Product Correction

Immediate Action Required

December 8, 2017

Product Name	List Number	UDI
ARCHITECT c4000 Cuvette Segment	02P75-01	Not applicable
ARCHITECT c8000 Cuvette Segment	01G46-01	Not applicable
ARCHITECT c16000 Cuvette Segment	09D32-05	Not applicable

The following pictures show examples of cuvette segments where the base is detached from the vertical support post.

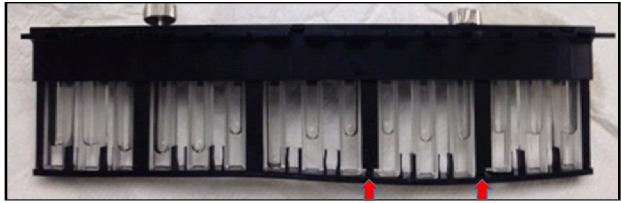
The base of the ARCHITECT Cuvette Segment may become detached under specific conditions. When a cuvette segment base is detached, cuvettes may be seated lower than the designed height. This may result in inadequate dispense into specific cuvettes due to the sample probe being unable to make efficient contact with the cuvette bottom.

The red arrows indicate where the base has become detached from the vertical support posts

If a cuvette segment with a detached bottom is identified, replace it before performing any additional testing on your ARCHITECT Clinical Chemistry System.
